# ENGINEERING BULLETIN

Ref Document No.	EB15014	Issue No.	1
Subject	Float Sensor Magnet Coating		
Release Date	28/07/15		
Associated Bulletins	N/A

COALTRAM® models CT08, CT10, CT10LP & CT13

Figure 1: Coated end of shaft magnets.

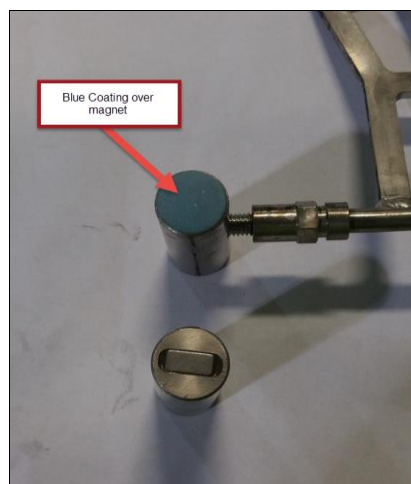
The scrubber float sensor shaft recently had an Engineering change which involved coating the end of shaft magnet to prevent corrosion. The harsh conditions of the scrubber has been causing the magnet to corrode and expand. The expansion could cause binding between the magnet and Teflon bush resulting in "scrubber Held" shutdowns.

The coating of the magnet with a non-reactive material will reduce the likelihood and instances of "Scrubber Held" trips.

Figure 2 : V-Shaped Notch

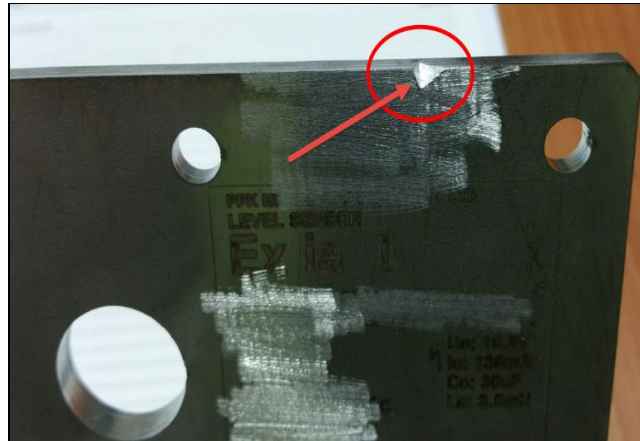
Additional to the register a recent request from one of our customers was to physically mark the float to easily identify that the change has been applied. A V-shaped marking on the top right hand edge near the serial number has been implemented. See Fig. 2.
